## PLANNING AND DEVELOPMENT DEPARTMENT STAFF REPORT

Item #: PZ2024-1355

### 3443 KESWICK COURT – STREAM BUFFER VARIANCE

Graded rear yard and installed stairs, pavers, and retaining walls

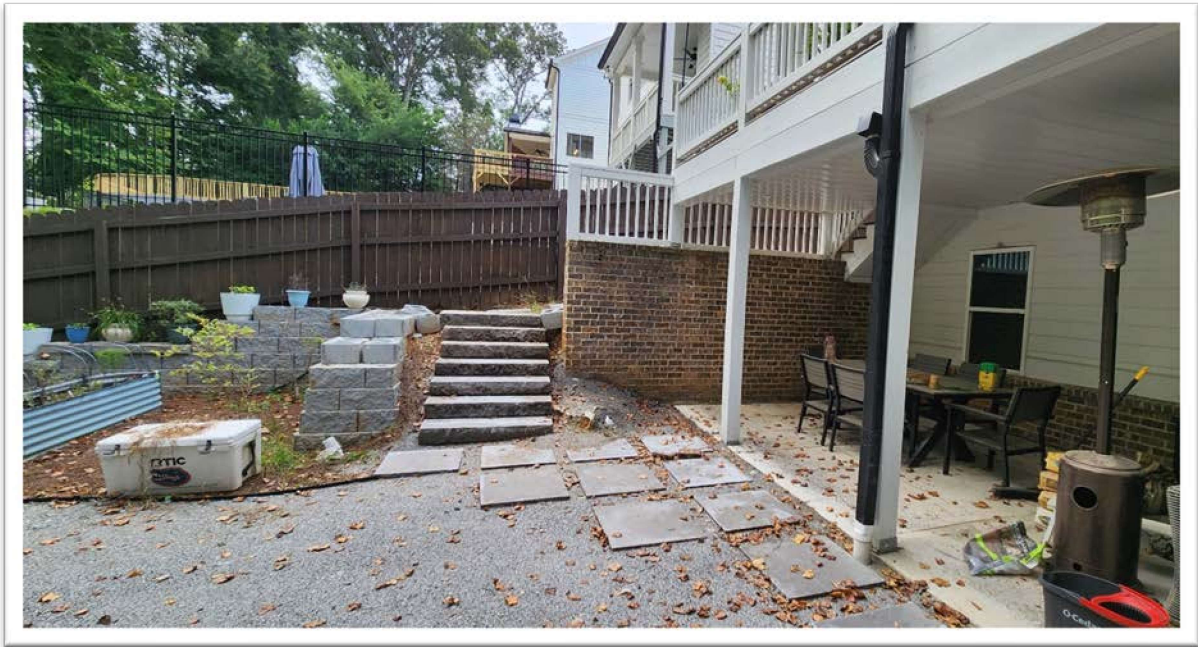
The property has an active code enforcement case, 20240994, for completing land disturbance and constructing a retaining wall without a permit. The completed work includes grading and installation of the 10-foot-tall retaining wall, sunken patio, steps and pavers.

The applicant has encroached into the 50- and 75-foot stream buffer setbacks for the installation of a 192 square foot sunken patio, 404 square feet of artificial turf, 195 linear feet of a modular block retaining wall with aluminum railing and a maximum height of 10-feet, 50 square feet of paver steps and 76 square feet of 2x2 steppingstones. The applicant proposes to bury a 50-gallon 3NDS flow-well and 62 linear feet of modified french drains for stormwater management. Plants are proposed including 10, 3-gallon shrubs within the 25- stream buffer. Overall, the project has increased the impervious surface of the site in the 50- and 75-foot stream buffer from 0 to 685 square feet and caused 26 square feet of disturbance in the 50-foot undisturbed stream buffer. The applicant is requesting a stream buffer variance to allow the unpermitted work to remain and to complete the instillation of the flow-well and french drains.

Installed sunken patio with retaining wall encroaching in the 50-foot buffer

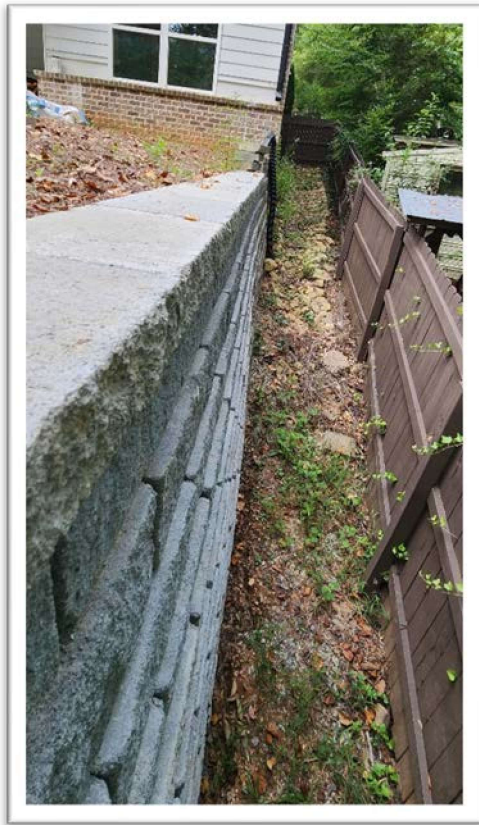
Much of the 75-foot buffer has been disturbed to accommodate the retaining wall and graded patio area. The limits of disturbance of the project total 2,232 square feet, of which 1,168 square feet fall within the 75-foot no impervious and 26 square feet in the 50-foot undisturbed buffer. The total impervious surface added is 685 square feet, of which 659 square feet placed in the 75-foot buffer and 26 square feet in the 50-foot buffer. Increasing the total impervious surface from 3,362 or 19.9% to 4,279 square feet or 25.3%.

The stream buffer variance request does not meet the variance procedural condition in Section 310-19(c)(4), as the actions of the property owner have created the conditions of hardship on the property, because the work was done prior to the variance request. Installation of the modified french drains and flow well, planting 10 evergreen shrubs within the 25-foot State stream buffer and the applicant's proposals to protect existing trees is protective of natural resources and the environment. However, it should be noted that the grading work that has been done in the 75-foot buffer has significantly altered the state of the buffer. Making it unknown if the extent of the Best Management Practices utilized for the project prior to the violation and if completion of the project is protective of the natural resources.

Should City Council approve the variance request, staff recommends the following conditions of approval:

1. The development shall be constructed in substantial conformity with the Site Plan and Elevations received by the Planning and Development Department dated received on August 20, 2024, with revisions required by conditions of approval as reviewed and approved by the Planning & Development Director.

2. The applicant shall utilize artificial turf with a high permeability rating reviewed and approved by the city engineer.
3. The applicant and their design professional shall coordinate with the city engineer to design best management practices (BMP) in accordance with the guidelines established in the Georgia Stormwater Management Manual (GSMM). The BMP shall be included in the land disturbance permit application and shall be inspected by city personnel during construction and prior to final sign-off by the city.

4. The applicant shall install an infiltration device to treat the area greater or equal to the rear yard encroachment. These devices shall include but are not limited to dry flow wells and drainage systems.
